Amendment 59 – City Hill Project

Figure 3.1 Indicative Building Form, Height and Landmark Buildings

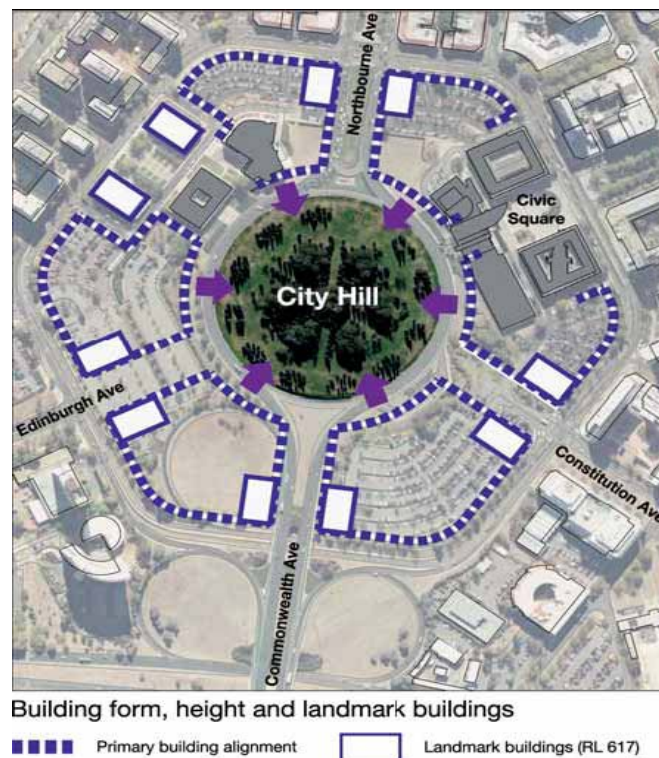
I believe all along that the key to developing the City Hill area – and I reiterate, I strongly welcome keeping City Hill as a park – is the connection of the spaces between the buildings that are, in my view, even more important than the buildings themselves, although I still feel that the idea of 16- to 18-storey buildings is just an anathema and contrary to the whole idea of this precinct.⁵⁶

- 3.50 Building height was the most contentious issue in relation to Amendment 59. Professor Ken Taylor was opposed to the proposal to have 16 to 18 storey landmark buildings. He could not see any rationale for increasing the current three storeys to four storeys.⁵⁷ He argued against filling this precinct in with buildings that could ruin the nature of the area.

- 3.51 The WBGS commented that ‘although precedents have been established for towers built to the RL617 limit in the City West precinct, they are not precedents worthy of emulation as works of architecture or as urban design gestures.’ The WBGS concluded that it ‘opposes the location of visually dominant structures in the vicinity of City Hill, and emphasises that Griffin explicitly called for horizontal development in Canberra.’⁵⁸

- 3.55 The WBGS commented that ‘no ground level and heritage vista studies are supplied to support the ‘landmark tower’ proposition, i.e. to establish whether the towers will indeed ‘read’ as meaningful landmarks and markers of Griffin’s geometry at ground level within the city or from significant vantage points in the National Capital.’⁶⁴

The scale of development is appropriate to achieve the objective for City Hill Precinct as a diverse mixed land use precinct and a vibrant heart to the city. The DA allows for buildings up to 25m (6-8 storeys) fronting City Hill. The Magistrates Court is a comparable scale (20m height) to what is proposed for building height and its setback is identical. This provides for enclosure of City Hill as intended by Griffin's plan, and will not overshadow City Hill Park. The 6-8 storey buildings will be set back approximately 30 metres from the park and there is no evidence that buildings of this scale will have significant negative wind impacts on the park. The DA should be amended in relation to the 25 metre building height to allow minor building elements above 25 metres where this enhances architectural quality and environmental performance to ensure consistency with DA60 and DA61.

It is likely that public buildings fronting City Hill Park (eg. new Supreme Court and Legislative Assembly buildings) will be lower rise buildings. Tall landmark buildings up to RL 617 (generally 14-18 storeys) are restricted to the corners of main avenues intersecting with London Circuit. This location reinforces the geometry of Griffin's plan and ensures no overshadowing of City Hill Park. These taller buildings will be set back more than 100m from City Hill Park.⁶¹
